# AMERICA'S CUP CLASS

## CONFIDENTIAL INTERPRETATION No 13

April 26, 2006

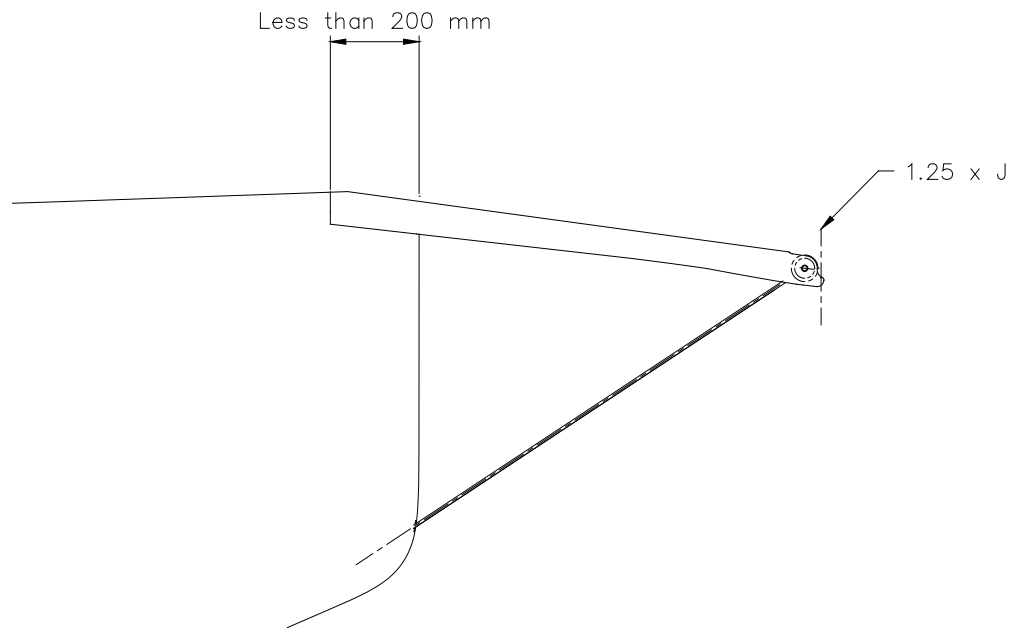
*Does the attached diagram of a bow / bowsprit arrangement satisfy the requirements of the America's Cup Class Rule as to location and positioning?*

For the purpose of Rule 2.5(e), "*at or above deck level*" shall apply to the uppermost surface of the spar over its entire effective length.

Further, in the context of Rule 2.5 (e), "*deck level*" shall be deemed to be the lowest point on the top surface of the deck at a transverse section 200mm aft of the foremost part of the hull.

Accordingly the bowsprit shown in the above diagram does not satisfy the requirements of the Americas Cup Class Rule as to location and positioning.
